NUREG-2153
Volume 1

Final Safety Evaluation Report for Combined Licenses for Virgil C. Summer Nuclear Station, Units 2 and 3

Office of New Reactors

Figure 2.5.2-2. UCSS Model
(Reproduced from VCSNS COL FSAR Figure 2.5.2-213)

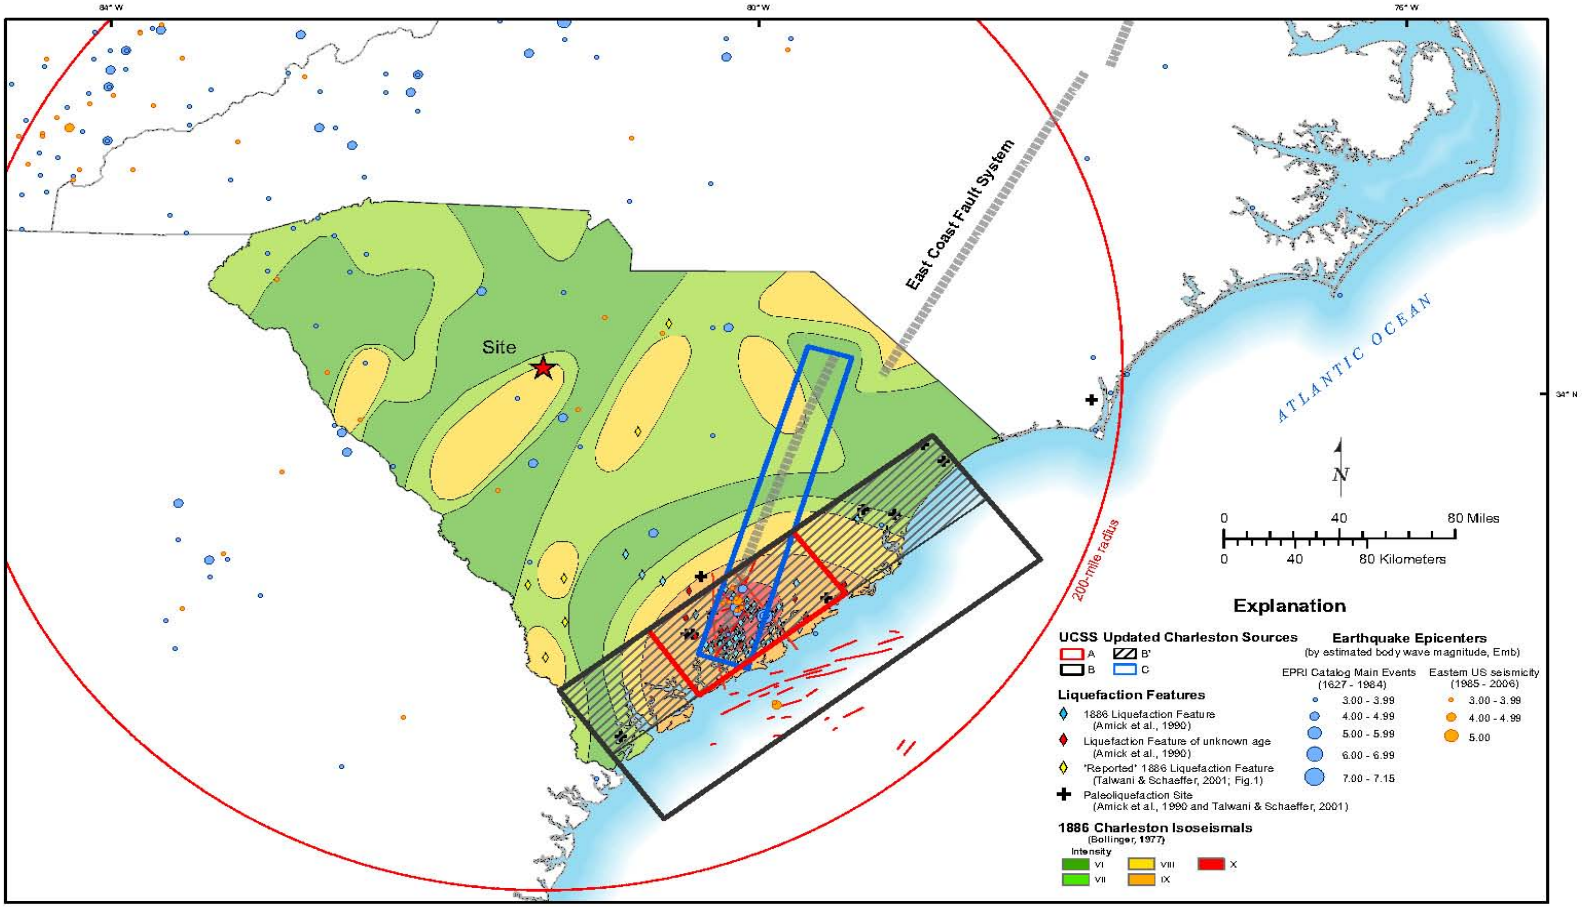
The applicant stated that the UCSS model includes four mutually exclusive source zone geometries and associated weights, referred to as A (0.7), B (0.1), B' (0.1), and C (0.1). These geometries, which are depicted in SER Figure 2.5.2-2, are based on: current understanding of geologic and tectonic features in the 1886 Charleston earthquake epicentral region; the 1886 Charleston earthquake shaking intensity; distribution of seismicity; and the geographic distribution, age, and density of liquefaction features associated with both the 1886 and prehistoric earthquakes. The applicant noted that Geometry A coincides with: the 1886 earthquake MMI X (severe damage) isoseismal (Bollinger 1977); the majority of identified Charleston-area tectonic features and inferred fault intersections; the area of ongoing concentrated seismicity; and the area of greatest density for the 1886 and prehistoric liquefaction features. Source zone B encompasses Geometry A and also extends beyond the Northeastern and Southeastern boundaries include paleoliquefaction features mapped by Amick (1990), Amick et al. (1990a, 1990b), and Talwani and Schaeffer (2001) and also extends offshore to include the Helena Banks fault zone. Geometry B' is identical to Geometry B, however it does not include the offshore Helena Banks fault zone. Geometry C envelops the southern segment of the ECFS as depicted by Marple and Talwani (2000).

Figure 2.5.2-3. New Madrid Faults from the Clinton ESP Source Model
(Reproduced from VCSNS COL FSAR Figure 2.5.2-217)

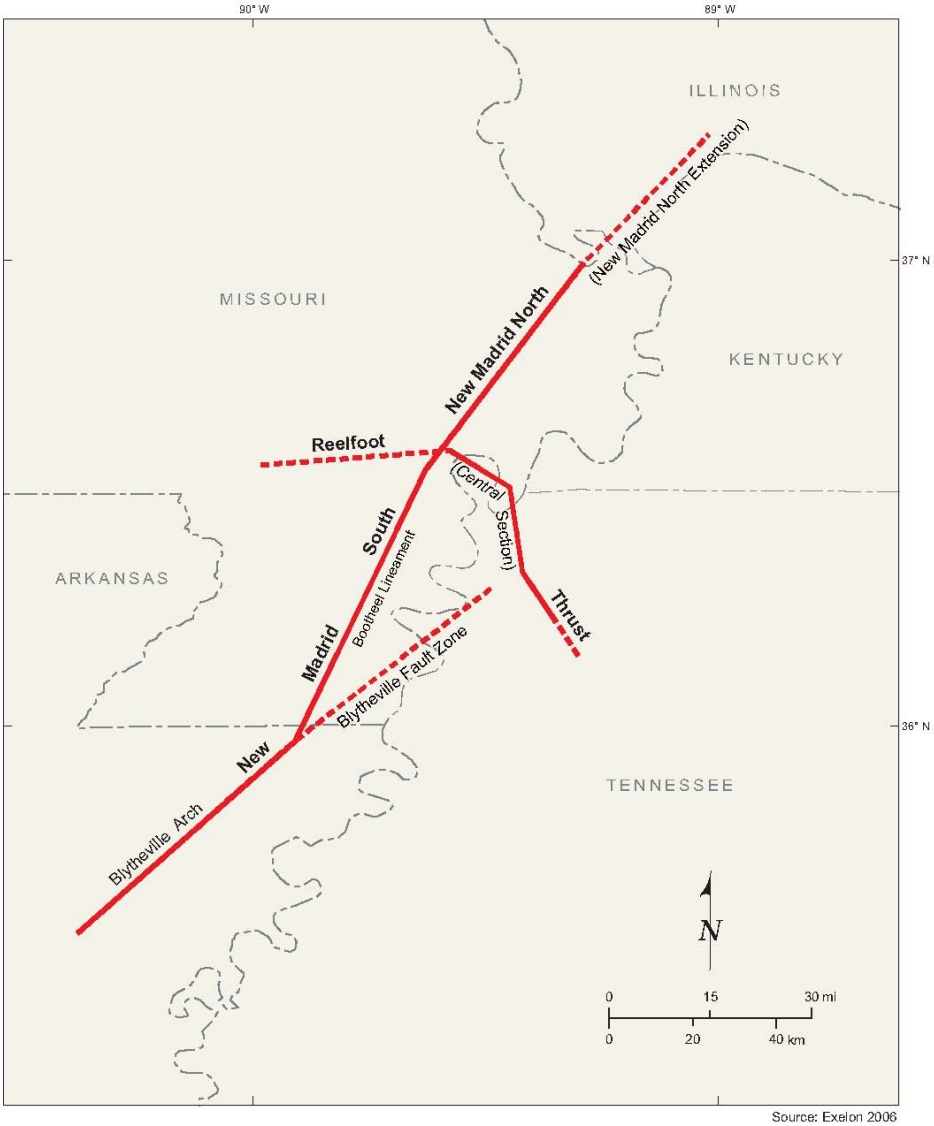
SER Figure 2.5.2-3 shows the New Madrid faults from the Clinton ESP source model. The applicant stated that the following three sources are identified in the NMSZ, each with two alternative fault geometries, which are provided in parentheses: Southern New Madrid (Blytheville arch/Bootheel Lineament, Blytheville arch/Blytheville Fault Zone); Northern New Madrid (New Madrid North, New Madrid North Plus Extension); and Reelfoot fault (Reelfoot Central Section, Reelfoot Full Length). The applicant stated that earthquakes in the NMSZ are treated as characteristic events in terms of magnitudes (similar to the UCSS model). The applicant stated that the magnitudes and weights for the New Madrid source faults (from the Clinton ESP model [Exelon, 2006]) are provided in VCSNS COL FSAR Table 2.5.2-221. The applicant noted that the characteristic magnitude ranges extend ±0.25 magnitude units above and below the indicated magnitudes in FSAR Table 2.5.2-221.

Figure 2.5.2-10. 10^{-5} Hard Rock UHRS (Depicted by Red Circles) and 10^{-5} High- and Low-Frequency Response Spectra (Depicted by Solid Blue and Dashed Green Curves, Respectively)
(Reproduced from VCSNS COL FSAR Figure 2.5.2-243)

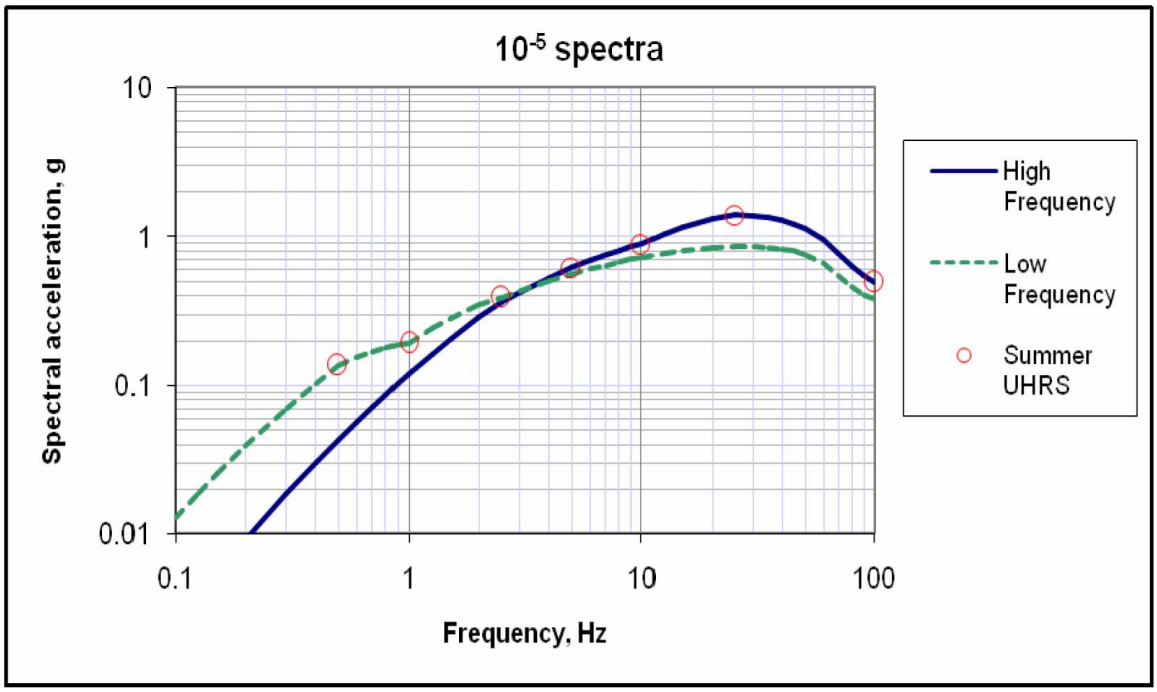
To develop the smooth 10^{-5} UHRS, the applicant repeated the above process using the 10^{-5} UHRS values from VCSNS COL FSAR Table 2.5.2-217, the controlling earthquake magnitude and distance values shown in FSAR Table 2.5.2-218, and the hard-rock spectral shapes for CEUS earthquake ground motions recommended in NUREG/CR-6728. The resulting 10^{-5} high- and low-frequency spectra are shown in SER Figure 2.5.2-10. The applicant then developed the smooth 10^{-5} UHRS from the envelope of the high- and low-frequency spectra shown in SER Figure 2.5.2-10.
